NOTICE OF VIOLATION

INSPECTION REPORT

Electrical Corporation:	San Diego Gas & Electric Company
Report Number:	CAD_SDGE_LOK_20241105_1318
Inspector:	Lovepreet Kaur
WMP Year Inspected:	2024
Quarterly Data Report (QDR) Referenced:	Quarter 2 (Q2)
Inspection Selection:	Energy Safety viewed the contents of the Q2 QDR and performed an analysis that resulted in the selection of the WMP initiatives and locations referenced in this report.
Relevant WMP Initiative(s):	8.1.2.10.1 Avian Protection Program (WMP.972)
Date of inspection:	November 5, 2024
City and/or County of Inspection:	Bonsall, San Diego County
Inspection Purpose:	Assess the accuracy of SDG&E’s QDR data, completeness of its work, compliance with WMP requirements, and compliance with its protocols.

Item1G1mg1: Overview of pole

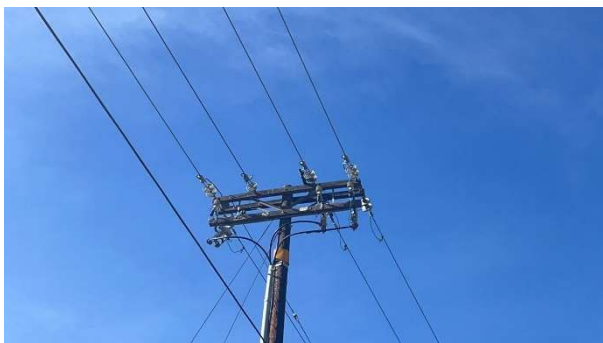
On Pole ID P10153, Grid Hardening ID 530000338531-P10153 at S Mission Rd, Bonsall, CA, 92003, USA, 33.2962825517085, -117.22395643603214, the inspector observed that the avian protection program was not completed at the location as one avian cover was seen dislodged and no other phases were covered. The inspector's observation is documented in Violation 1 photographs, which are attachments to this report. Photo numbers Item1G1mg1, Item1G1mg2, Item1IA1mg1, and Item1IA1mg2 depict that avian protection is dislodged on the center phase, and no other avian protections were visible.

Item1IA1mg1: Avian protection is dislodged on the center phase, no other avian protections visible

Item1IA1mg2: Avian protection is dislodged on the center phase, no other avian protections visible
